AMENDMENT OF SOLICITATION / MODIFICATION OF CONTRACT		1. Contract Number	Page of Pages 1 3
2. Amendment/Modification Number DCKT-2011-B-0037-0005	3. Effective Date See 16C Below	4. Requisition/Purchase Request No.	5. Solicitation Caption Storm Water Mgmt System

12. Accounting and Appropriation Data (If Required)			
13. THIS ITEM APPLIES ONLY TO MODIFICATIONS OF CONTRACTS/ORDERS, IT MODIFIES THE CONTRACT/ORDER NO. AS DESCRIBED IN ITEM 14

14. Description of Amendment/Modification (Organized by UCF Section headings, including solicitation/contract subject matter where feasible.) Solicitation DCKT-2011-B-0037 is amended to provide formal answers to questions posed by potential bidders and to include additional specifications, revised drawings details and attachments as outlined on Pages 2-3 of this amendment.			
Except as provided herein, all terms and conditions of the document referenced in item (9A or 10A) remain unchanged and in full force and effect.			
15A. Name and Title of Signer (Type or print)		16A. Name of Contracting Officer James Roberts	
15B. Name of Contractor (Signature)	15C. Date Signed	16B. District of Columbia  (Signature of Contracting Officer)	16C. Date Signed 1/

TYPICAL SIDEWALK SECTIONS

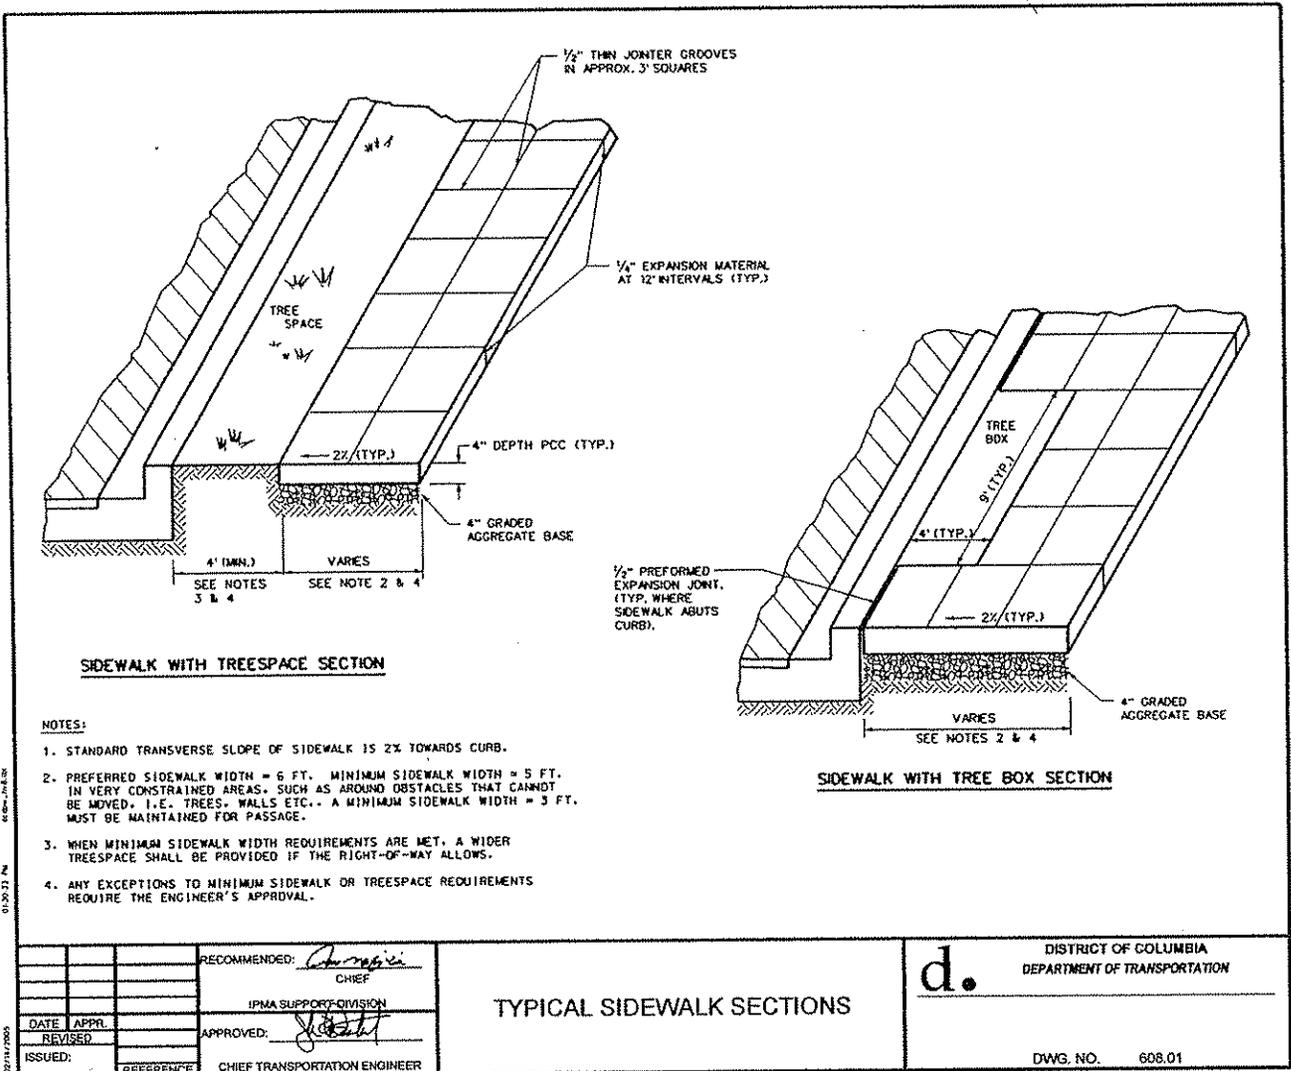
Q.2 There is a specification section 321373 – Concrete Paving Joint Sealants. There are no drawing details given for this specification section. Please provide drawing details so we can price accordingly.

A.2 The concrete pavement for this site is concrete sidewalks. The detail is shown in C3.13. Please see attached DDOT standard sidewalk detail (Attachment No.2) for your reference.

SITE IMPROVEMENT PLAN - EAST

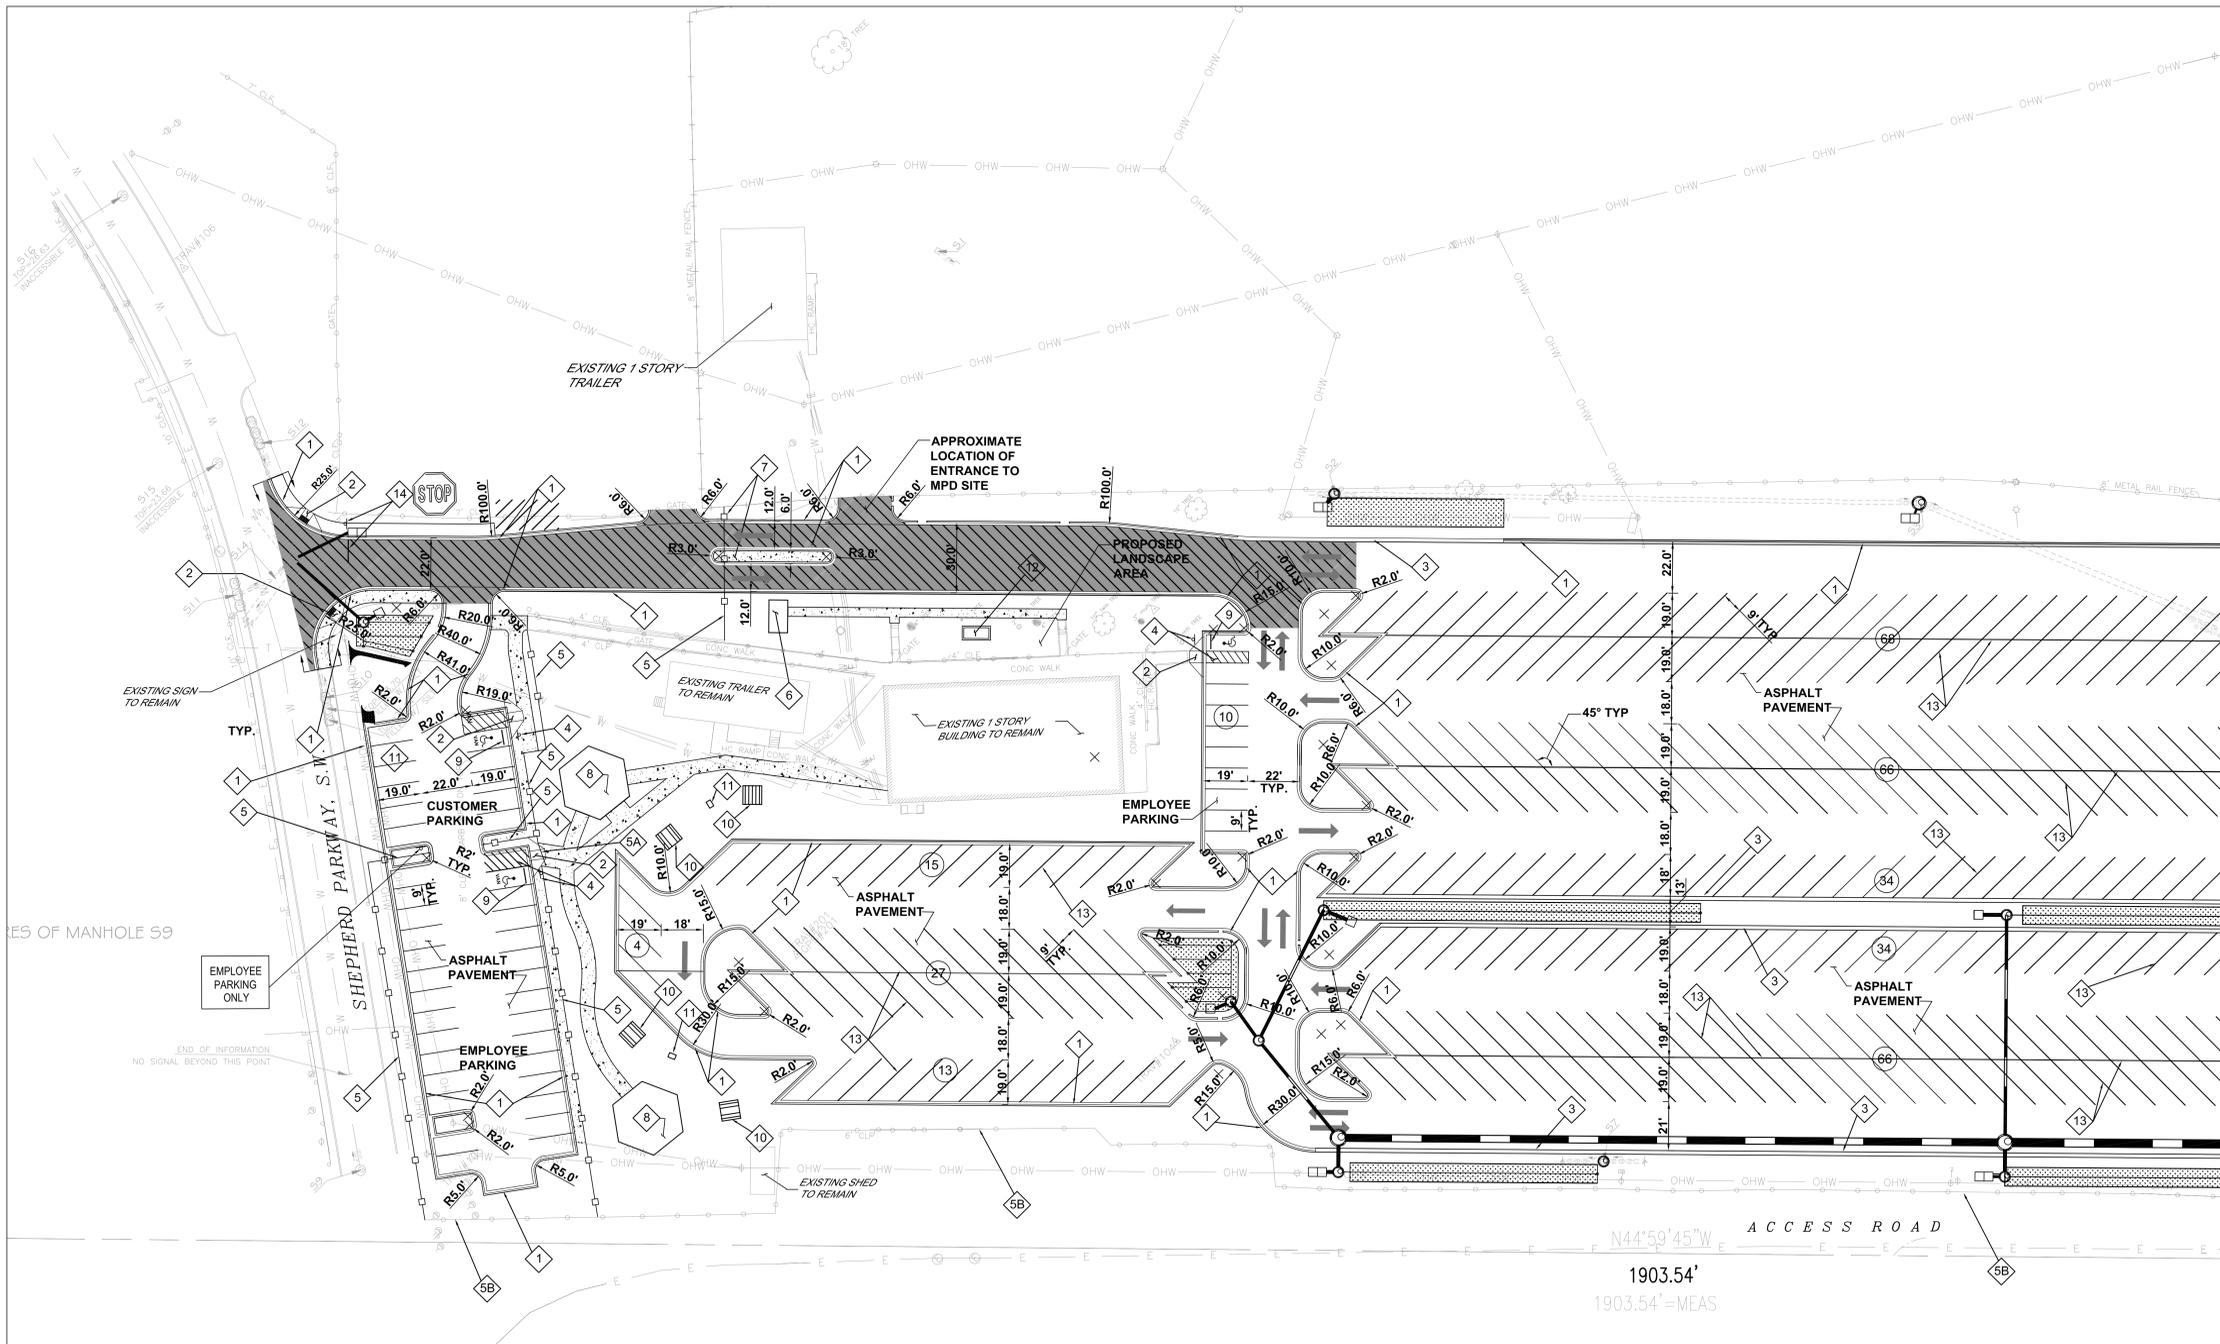
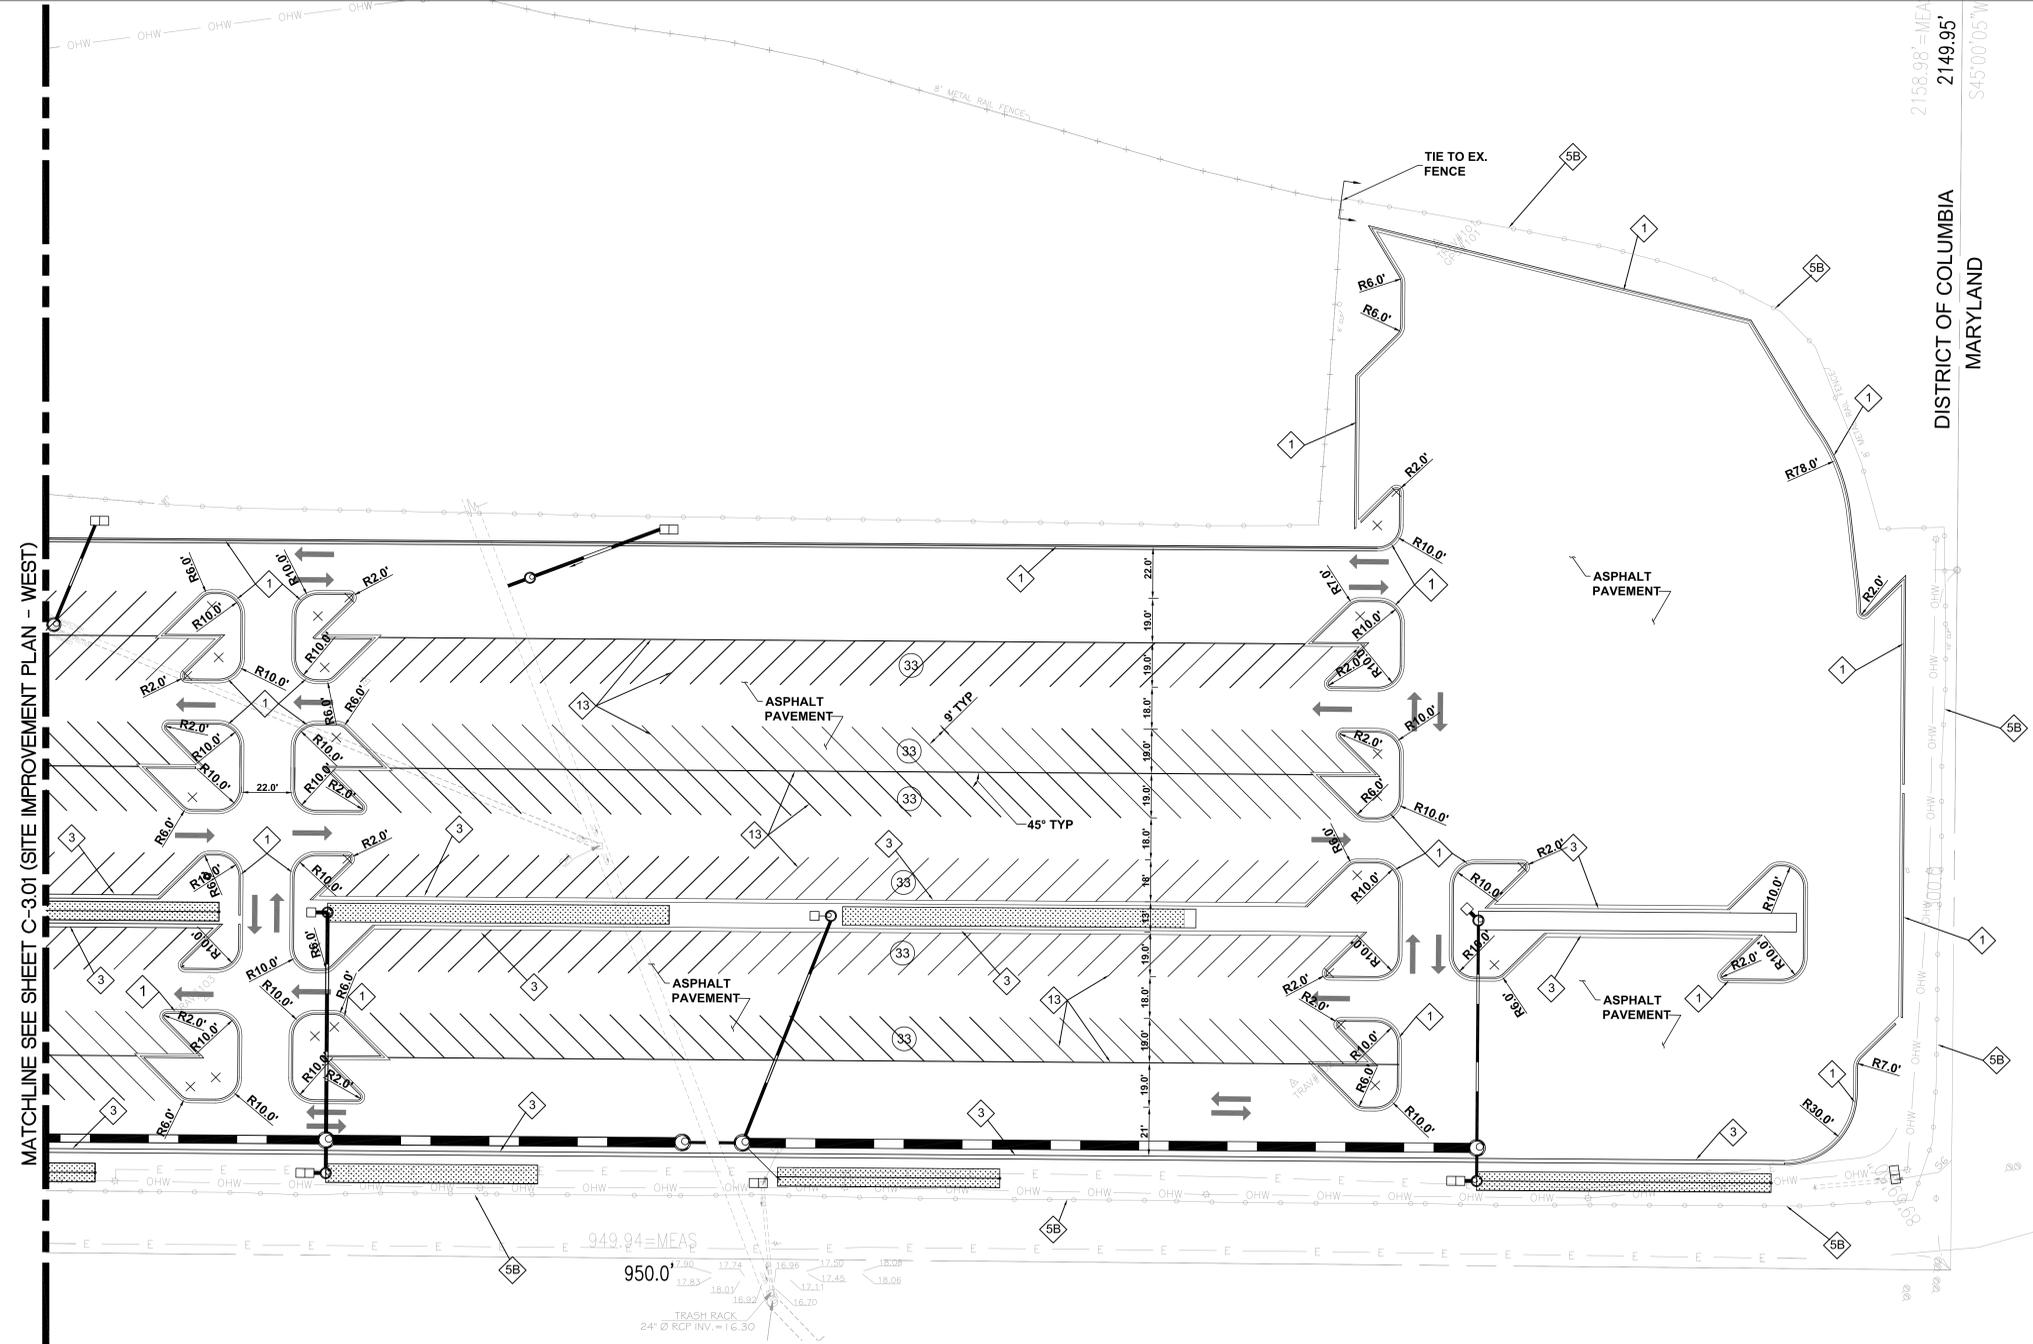
Q.11 Drawing C-3.13 shows typical asphalt parking lot pavement section and typical asphalt road way pavement section. However, drawings C-3.00 and C-3.01 don't identify which section is for parking lot or road way. Please provide appropriate site plan to distinguish the two typical pavement sections.

Q.13 Drawing C-3.00 and C-3.01, Site Improvement Legend Item #5B states. "The existing fence to be re-set/repared per Owner's directions". Please provide additional information, details, and locations for resetting and repairing the existing fence.

Q.21 On Sheets C-3.00 and C-3.01 the Site Legend Shows a Detail for the Heavy Duty Asphalt however it doesn't specify where the Heavy Duty Asphalt should be applied except in the "entrance area" of the plans. Can you provide the limits of the Heavy Duty Paving or confirm the government's intent on the drawing attached based on our assumption?

A.11 See revised Drawings C-3.00 and C-3.01 in Attachment No. 5, which show the limit of the roadway and parking lot pavement.

A.13 The Contractor shall repair eight (8) holes in the existing perimeter chain link fence, along the far southeast corner of the property. This repair work is in lieu of the requirement of Legend Item No.5B on Drawing C-3.00, See Attachment No. 5.

A.21 See revised Drawings C.3.00 and C.3.01, Attachment No.5.
